## Transport Axle Lifting Spring

### Models Affected: All Lawnaire IV and V's

Fig 1.

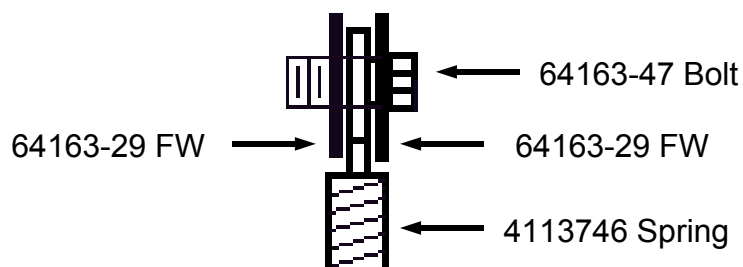
We have found that in certain conditions the **Lift Transport Springs 4113746** may come off.

You will have to install 2 - **64163-29 Flat Washers**, 1 on each side of the spring and replace the existing bolt with a **64123-47 Bolt**. Fig 1 below.
